DEPARTMENT OF MINES  
SOUTH AUSTRALIA

REPORT ON DRAINAGE PROSPECTS  
Pt. Section 95, Hd. Noarlunga.

Town Planner (for F. Hoffman).

Approved	Passed	Drn.	DRAINAGE SURVEY Pt. Sec. 95, Hd. Noarlunga. West Pt. C.T. 3187/4. TOWN PLANNER - F. HOFFMANN.	D.M.	Scale 80 ft. to 1 in.
		Tcd. M.L.		Req.	S 3951
		Ckd.			Ha 9
Director		Exd.			Date 12.11.64

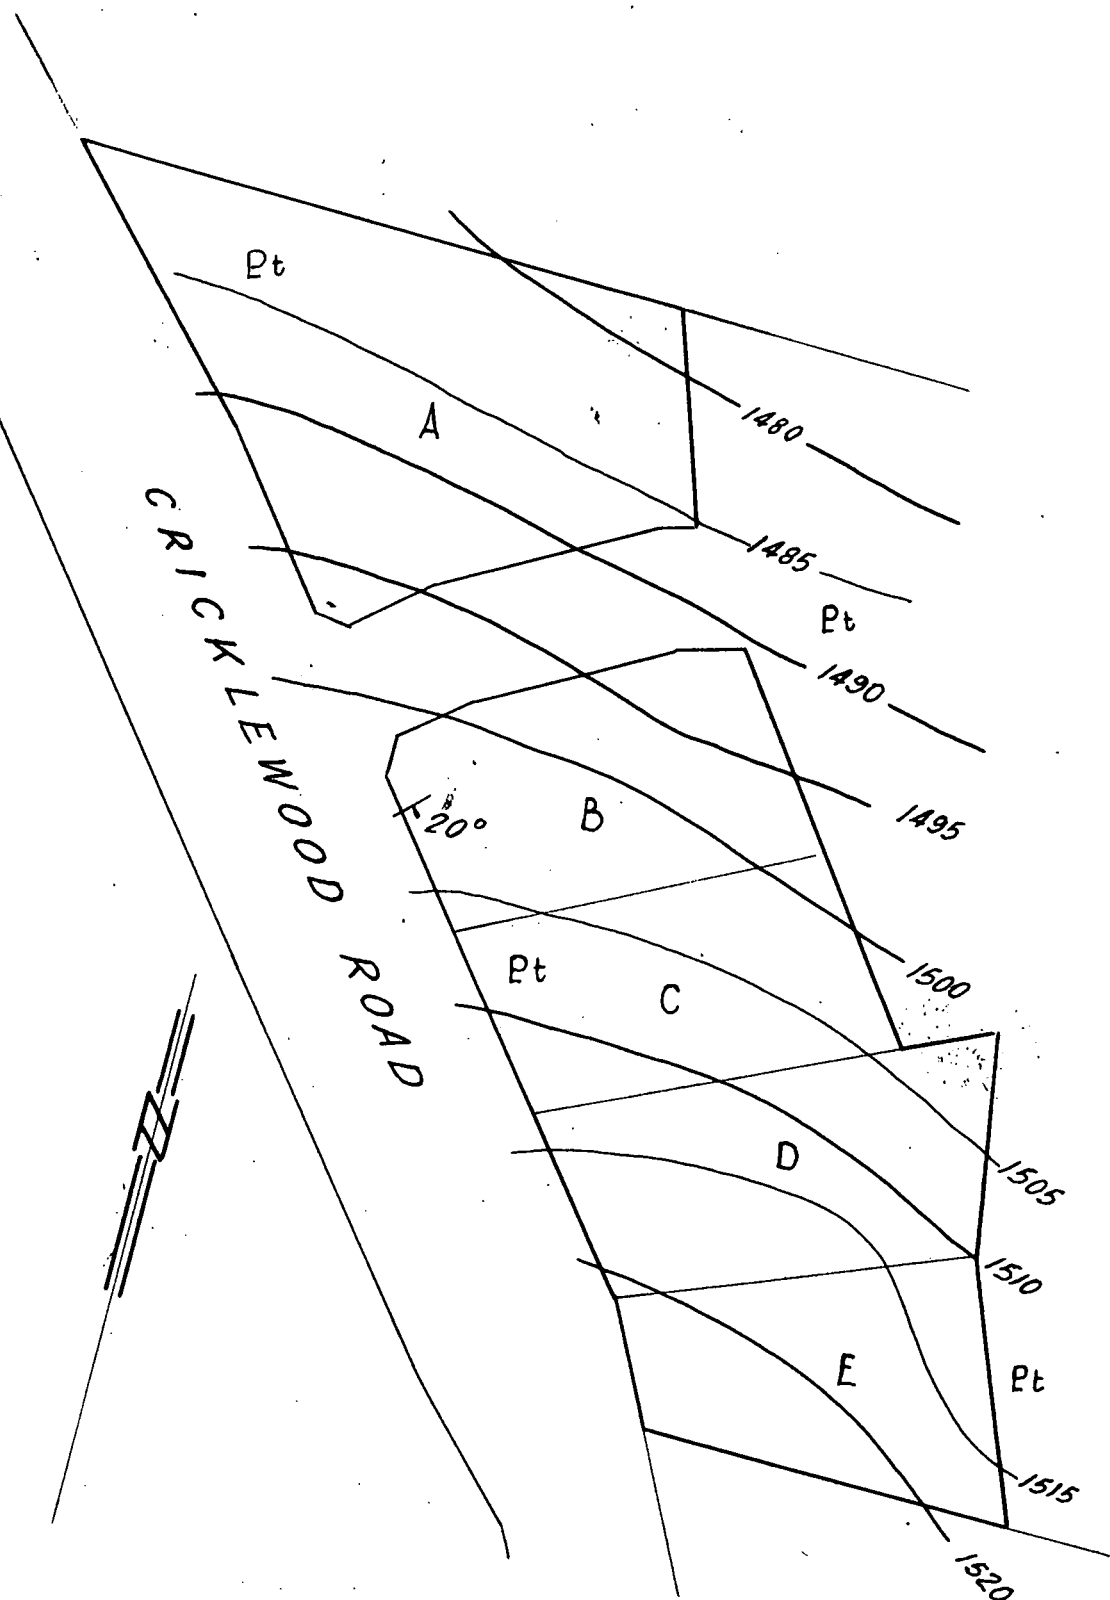
Some of the allotments in the proposed subdivision lying to the east may be affected by drainage from the higher blocks, particularly from "C", "D" and "E". In the proposed sub-division to the east allotment 8 would be most affected, and if development of both sub-divisions is considered, then it is suggested that allotment 8 be made into a reserve or incorporated into adjoining allotments.

If this and the adjoining sub-division are both to be developed then it is suggested that allotment 8 to the east be made into a reserve or boundaries altered to include in adjoining allotments.
